Denmark Link Road

Submissions Report

Transport for NSW | June 2021

Figure 1: Plan extracted from Extent Heritage July 2018¹

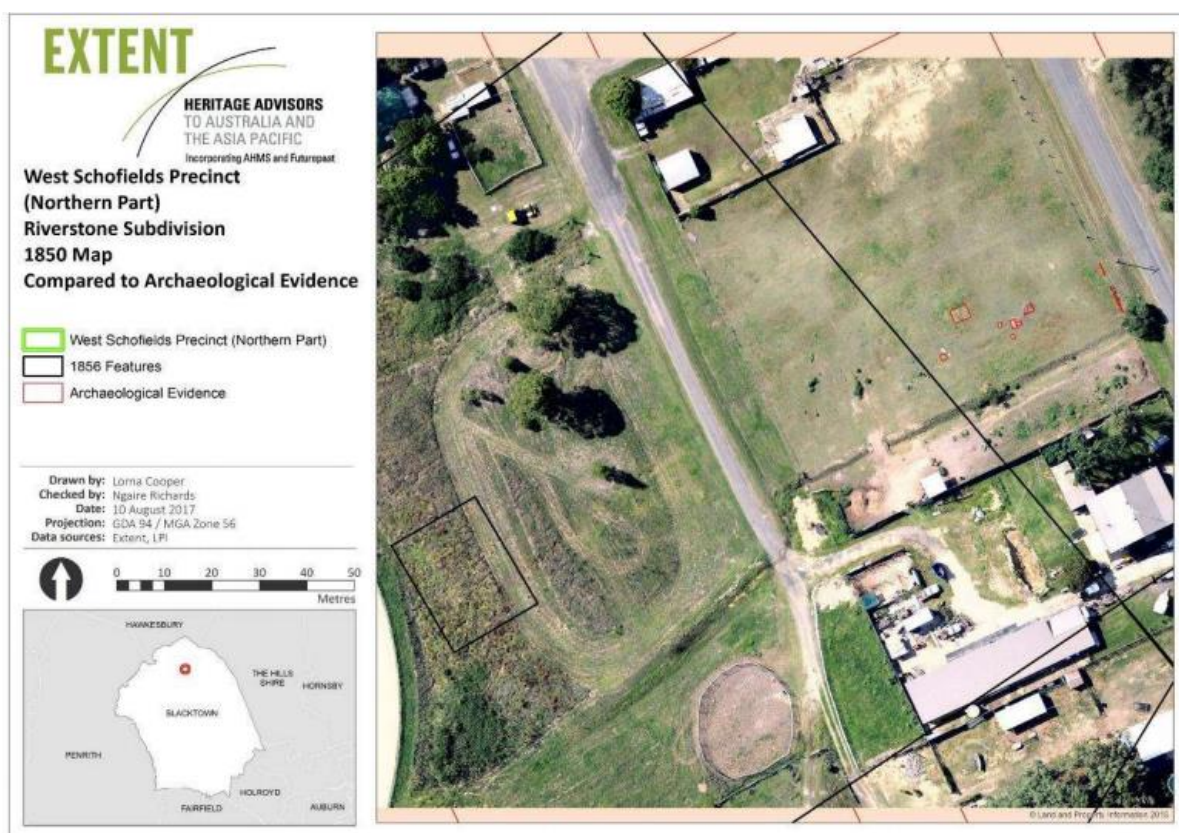
- Comment that there is possible archaeological potential associated with 37 Denmark Road (potential 1850s structure) as identified in the West Schofields Part Precinct (Northern Part) Non- Indigenous Heritage Assessment (Extent Heritage, 2018). Further research, including testing, of the identified

archaeological sites should be carried out verify the presence or absence of archaeological features and deposits

Extent's mapping of the archaeological evidence identified during field survey in comparison to the structure shown on the 1856 subdivision map is shown below as 'Archaeological Evidence.' The potential site is on the opposite side of Denmark Road from the former structure location, illustrated on Figure 1 as a black rectangle.

It is also noted that structures are visible in the 'Archaeological Evidence' location in the 1947 and 1961 aerials of the study area. The presence of concrete pads also suggests a 20th century construction date for at least some of these remains. This does not, however, discount the potential that archaeological evidence associated with an earlier historical phase does remain at this location.

Proposed works associated with the Denmark Link Road project would be located approximately 40 metres to the west of the identified remains and would include:

Figure 2: East Clive Estate subdivision plan, c. 1884. Source: SLNSW⁴

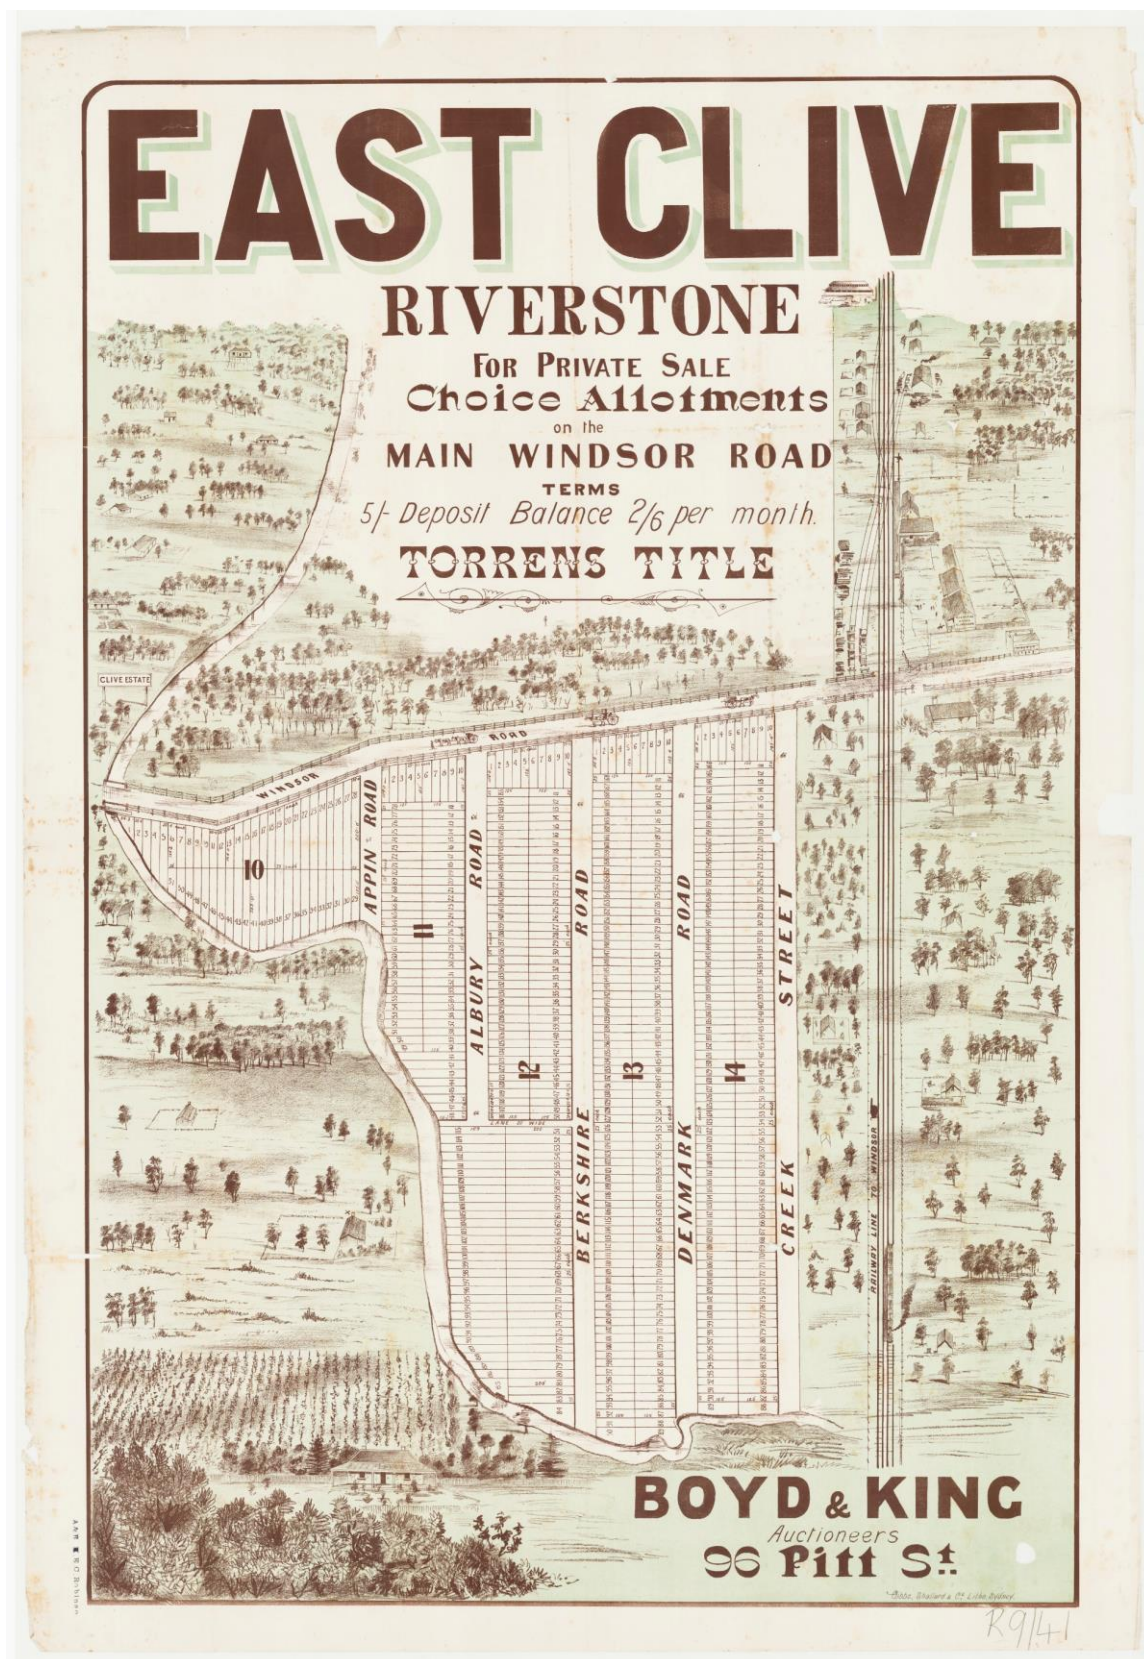
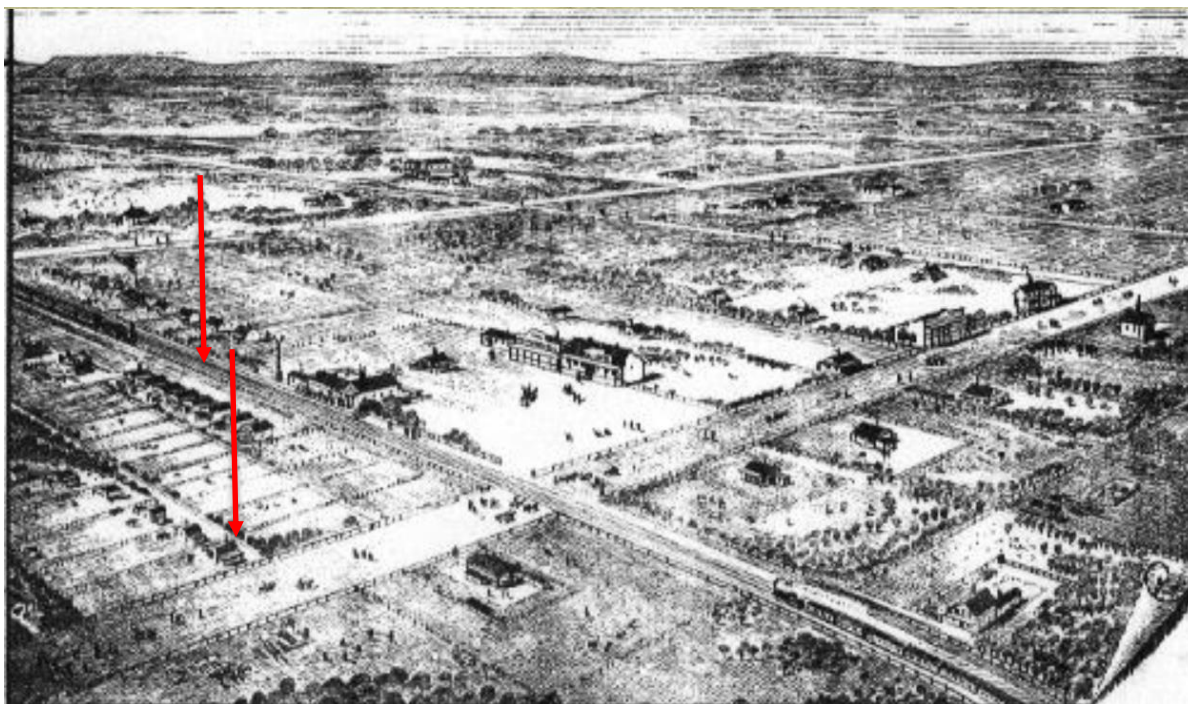
- Comment that there may be potential for archaeological finds associated with former buildings along Garfield Road, and therefore further investigation, including archaeological testing should be carried out

The c.1884 subdivision plan suggests that the portion of the study area to the north of Garfield Road was vacant at this time.² Based on the depth of the Richards Avenue workers housing blocks associated with the cottages in the c.1909 photograph, and assuming the current, later, cottages are in a similar orientation and location as these earlier cottages, the largest structures in the background of the c.1909 photograph is likely to have been located close to the intersection of Garfield Road and Carlton Street, rather than within the current Denmark Link Road study area.

The structures under discussion do not appear on the 1947 (or later) aerial photographs of the area. It is therefore possible that the structures were originally part of the Riverstone Meatworks, possibly an extension of the workers housing group on Richards Avenue. This pre-1947 date broadly conforms with the history of the workers cottage, the first phase of which were demolished in the first quarter of the 20th century. A second 'street' of cottages can be seen on both the c.1884 subdivision plan and on an real estate 1884 sketch of the area, reproduced below.³

Due to the assumed age of the former structures, archaeological evidence associated with the frontages of properties of this date tend to include postholes, footings and pad bases. Remains of this age and type are fairly ubiquitous. Artefact bearing deposits are more likely to be preserved in the rear yards of buildings dating to this period, associated with rubbish pits or decommissioned cisterns and/or wells. An *in situ* artefact bearing deposit associated with the late 19th century occupation of Riverstone, particularly if associated with the early 20th century construction of the first phase workers cottages associated with the Riverstone meatworks, may have some associative and historical significance.
